Peer Review of the HB02 Pump Test (October, 2009) and the PB Report  
“Broke Groundwater Investigation and Monitoring Report - AGL Hunter  
Gas Project”. Final Report.

Professor Garry Willgoose  
23 April 2010

**Figure 5.1:** Projected drawdown over time for the flow testing showing the projected drawdown using PB’s long time conductivity parameter (their Table 6.5  $K=0.005$  m/day) and the two sets of parameters derived by the peer reviewer (Table A3).

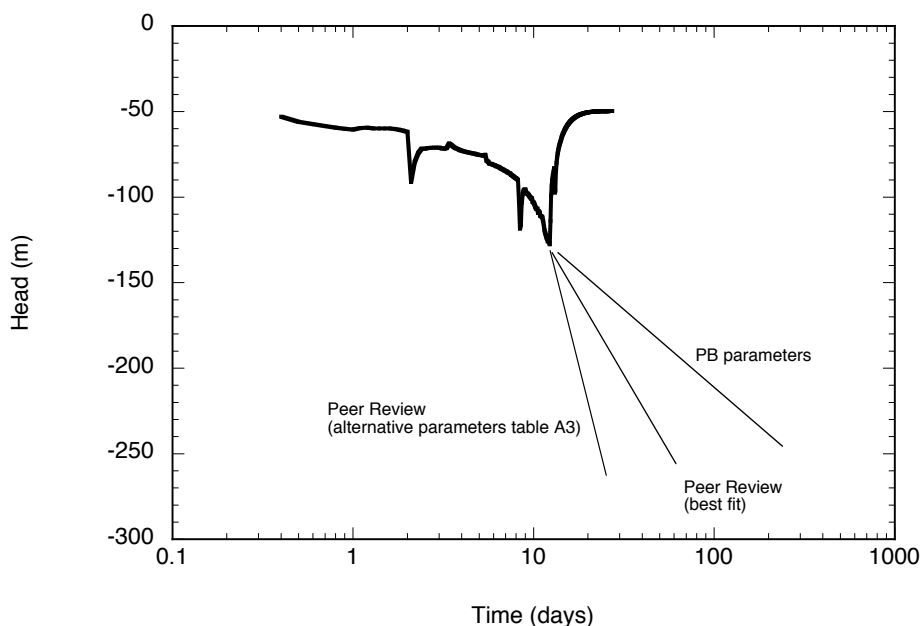
To estimate the drawdown over time for the flow testing it is simply a matter of extending the drawdown plot on the semi-log plot from the observed data to the head that is the objective of the flow testing. If the pumping rate is 0.20 litres/s (the final pumping rate in the last two days of the pump test, and the rate indicated by AGL as their design flow rate for the flow test) then the drawdown with time is given by the line in Figure 5.1. Three drawdown curves are given corresponding the conductivity derived by PB and he two alternative parameters sets derived by the peer reviewer. The change in head with time has been projected using the Jacob method. For the case where the conductivity is not changing with distance from the well, as is the case once you have left the fracted zone around the well, this method yields the same results as the groundwater model used in this report. While the differences between the parameter sets appear large the differences in the parameters are small given that the exact value of the parameters for all three parameter sets was strongly influenced by the pump test behaviour in the last two days of the well test. The flow test, which will run for a longer time

than the pump test will clearly give a better estimate for the conductivity away from the well as it will be easy to compare it against the three possible drawdown curves.

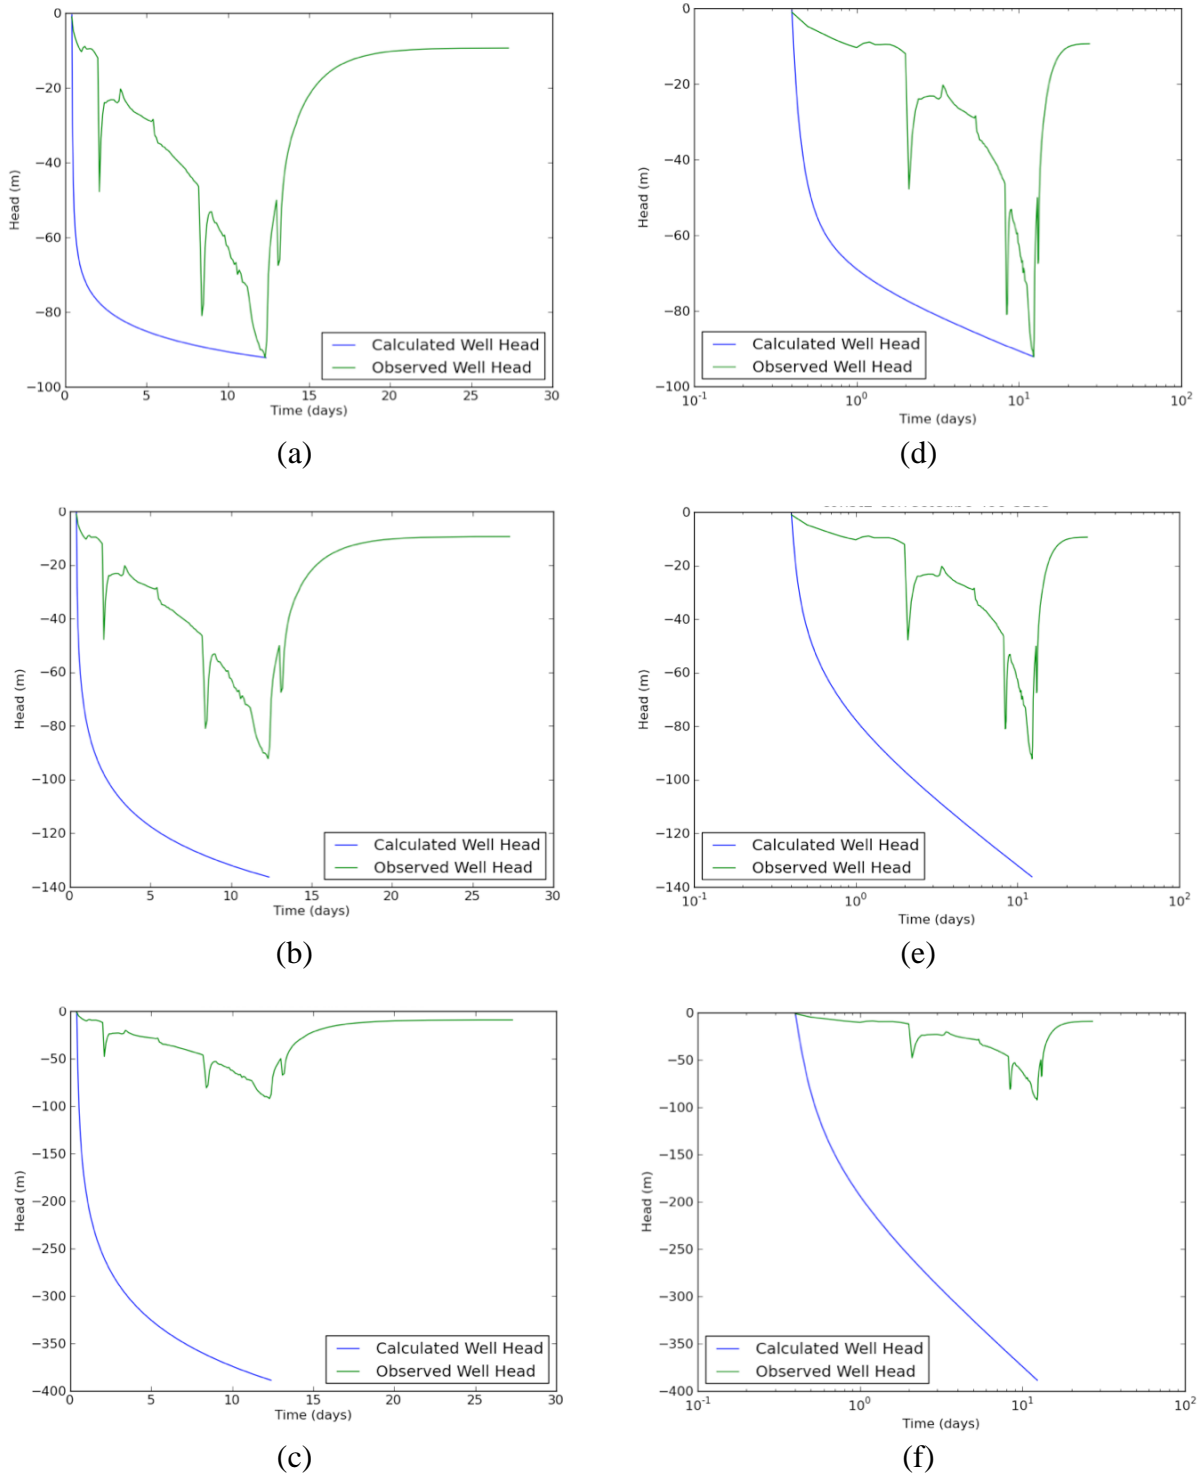
The first set of simulations used the 3 conductivities as derived by PB in their Table 6.5 and listed in Table A2. The pumping rate was the pumping rate for the period of the pump test for which the conductivities were derived. The time period listed in Table A2 is the simulation time used in the all of the figures below, which are relative to the start of the pump test. The results are shown in Figure A1.

The reader is cautioned that it is not expected that these results will fit the pump test data (also plotted in the Figures) because the simulations do not use the actual pumping rates (that change in time through the test). The figures are provided simply to show the rate at which convergence to asymptotic behaviour (i.e. linearity on the semi-log plot in Figure A1) occurs. It is clear that that in all cases it is several days, and in cases longer than the period over which the three conductivities are derived. This impacts on the conductivities derived by PB analysis, as it means that one of the assumptions of the Jacob method is invalidated. Finally, the asymptotic slopes of the 3 computer simulated drawdown curves are the same as the slopes of the regions of the pump test from which the conductivities were derived. This confirms that the computer code is yielding correct results given the conductivities used in the modelling.

However, as indicated in the PB report their estimate of conductivity reduces as the pump test proceeds indicating that the conductivity drops as you move away from the well. Figure A1 confirms this result.

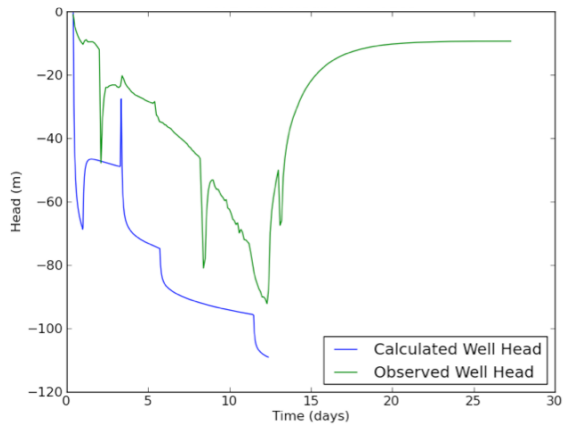
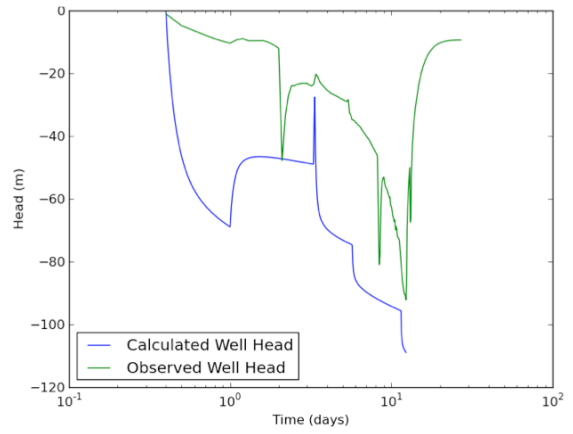
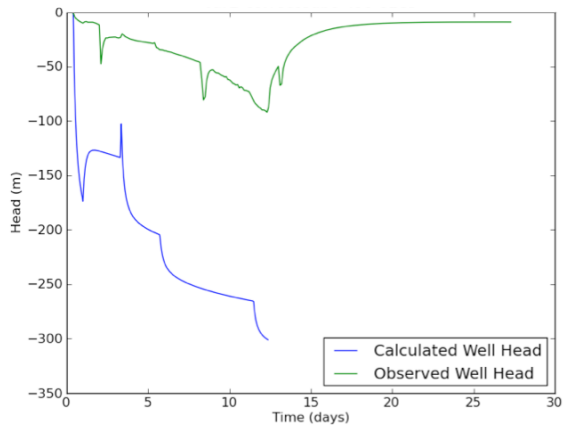
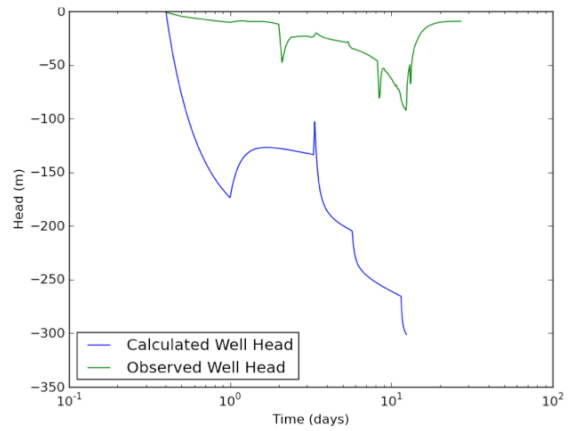
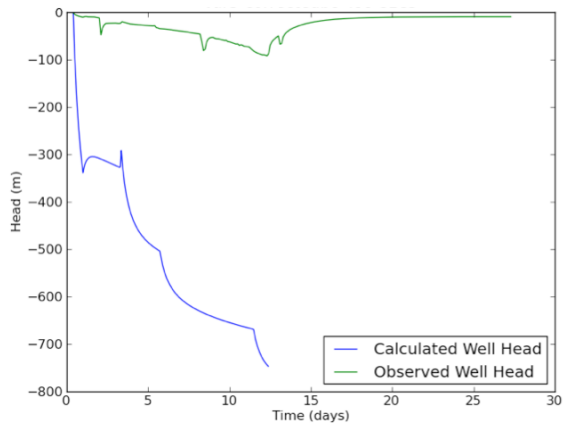
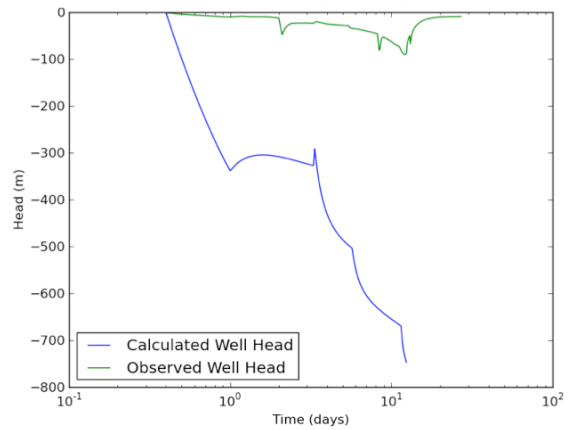
The second set of simulations repeated the first set of simulations but used the actual pumping rate as performed during the pump test. These results would be expected to provide a good fit to the observed well drawdown if the aquifer had the same conductivity everywhere in the aquifer as used in the computer model. These results are shown in Figures A3 and A4. None

of the conductivities provide a good fit to the data and in the following sections explore some alternative conductivity cases will be explored. The poor results in Figure A2 confirm that the aquifer conductivity is not constant in space.

However, one important conclusion is consistent with the PB interpretation of the time trend of the pump test. As the pump test proceeds the observed rate of well drawdown steepens (i.e., the drawdown curve gets steeper with time, particularly obvious in Figure A2d-f). Figures A1 and A2 show that this steepening is unlikely to be a result of the increasing pumping rate during the test because the model does not show a similar trend. Rather it is likely to be a result of a decreasing conductivity of the aquifer with distance from the well. This supports the conclusions in the PB report that, even though they misapplied the Jacob method (and thus their conductivity estimates are likely to be inaccurate so their conductivities are likely to be too low), their conclusion that the aquifer conductivity decreases with distance from the well is likely to be correct.

**Figure A3:** The best fit parameters for the first 5 days of the pump test (a) the PB conductivity  $K=0.043\text{m/day}$  (b) a sensitivity study with  $K=0.08\text{m/day}$

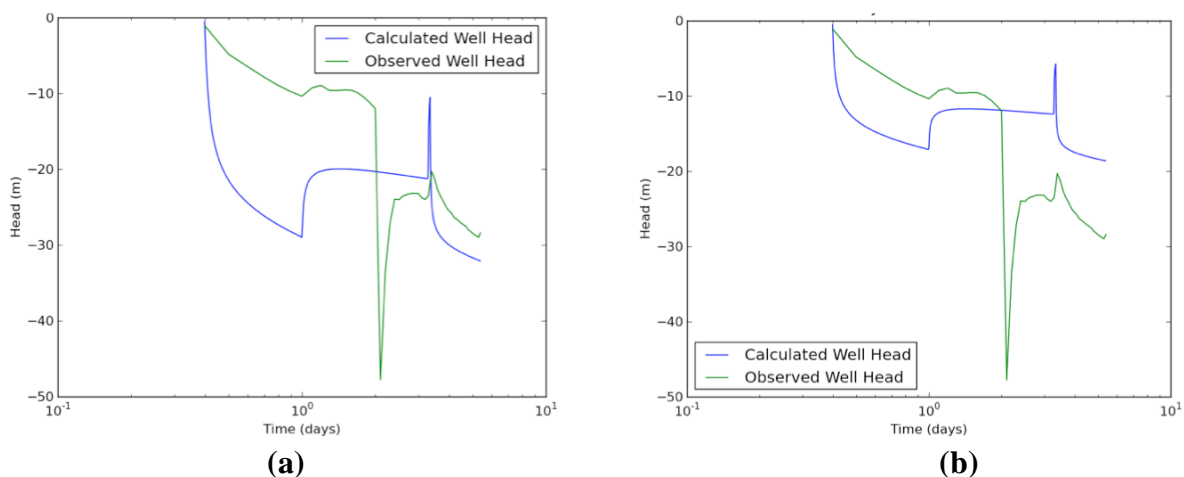
The parameters fit by PB to the first day of the drawdown do provide the best fit to the first 5 days of the data (Figure A3). The initial amount of drawdown is too large, but this is function of the storativity not the conductivity. The match in conductivity is indicated by the match between the slopes of the data and model results. Figure A3 also shows a result for a slightly higher conductivity of  $K=0.08\text{m/day}$ , which shows the sensitivity to a change in conductivity. The initial drawdown is less but the rate of subsequent drawdown is too low.

**Figure A4:** Best spatially variable conductivity (a) (b)  $K=0.08\text{m/day}$  at well, (c) (d)  $K=0.043\text{ m/day}$  at well.

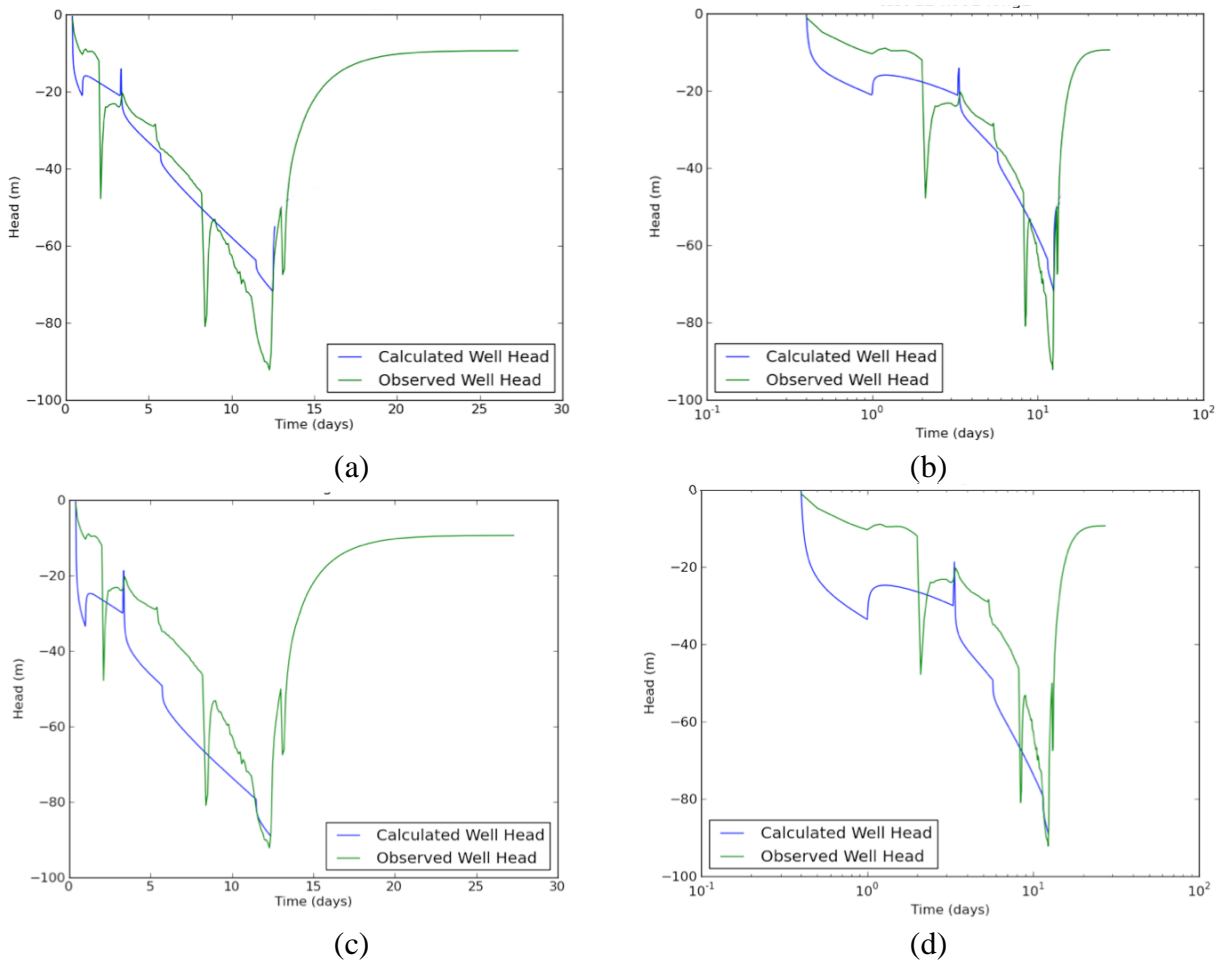
Accordingly a number of configurations for the spatial variation in conductivity were investigated. It was not possible to obtain a good fit to the overall drawdown if the initial conductivity of  $K=0.043\text{m/day}$  was used but good fits were obtained with an initial conductivity of  $K=0.08\text{m/day}$  (Figure A4).

The result in Figure A4 uses a linear drop in conductivity with distance from the well. The conductivity at the well is  $0.08\text{ m/day}$ , dropping down to  $0.005\text{ m/day}$  at  $10\text{m}$  and dropping to  $0.001\text{m/day}$  at  $12\text{m}$  and then  $0.0001\text{ m/day}$  at  $18\text{m}$  and further out. This suggests that as the

4. With respect to the sensitivity to storativity in days 9-12 it can be observed in Figure A4(a) that the model does not track the increase in slope of the drawdown. No combination of reduced conductivity at a far distance allowed accurate tracking of

**Figure A7:** Simulations of well drawdown in the presence of leaks at (a) No leak baseline case, (b) 5m from well, (c) 10m from well, (d) 20m from well.

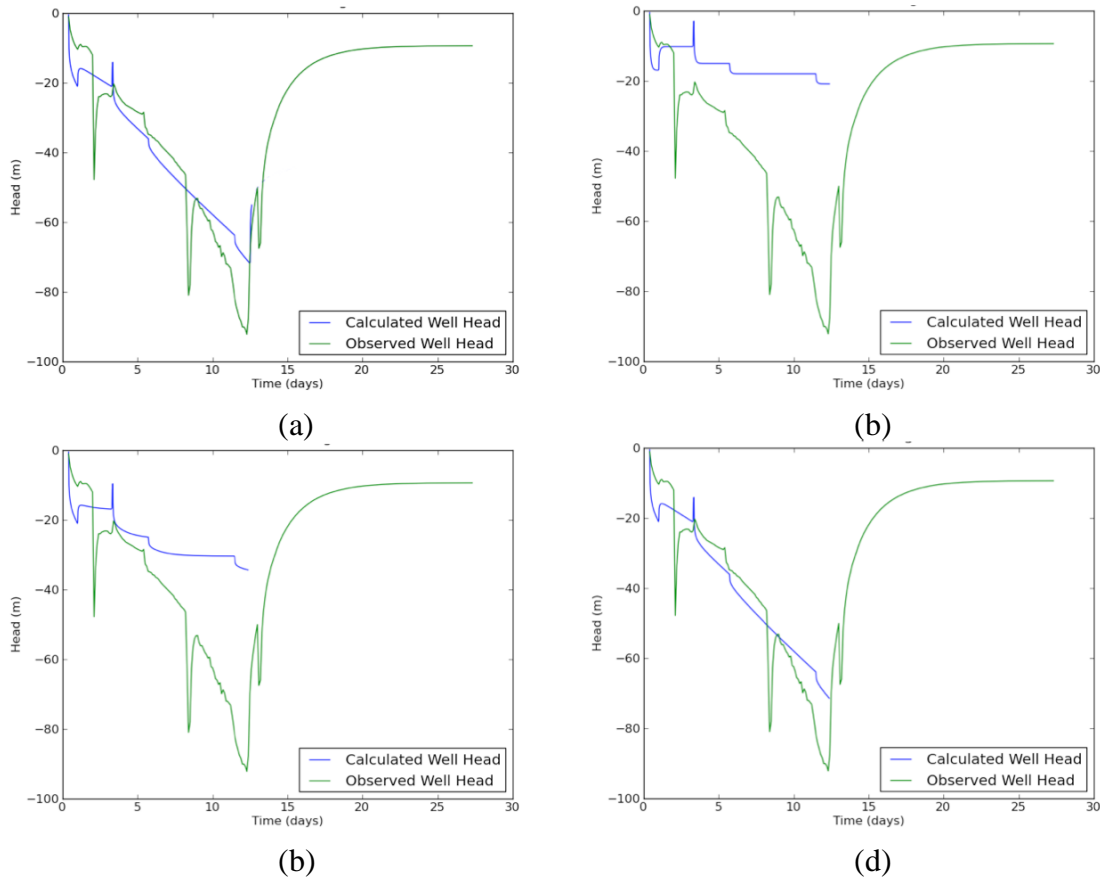
- (b) The second is that a point leak exhibits itself as a reduced drawdown in the well. This is because the leak means that it is easier to extract water from aquifer because you are not only drawing from the aquifer but from the leaky point. This is because the leak is replacing water that has just been pumped out.

- (c) The classic symptom of a point leak is that the drawdown curve is concave up (i.e. its get less steep with time) and it tends to a horizontal line with time (the steps in the horizontal line in Figure A7 reflect changes in the pumping rate during the

The conclusion of this analysis is that the well drawdown from the pump test does not show any of the classical symptoms of a point leak located within the cone of depression created by the pump test. Accordingly I conclude that there are no point leaks within the cone of depression (within about 20-50m of the well) created by the pump test.
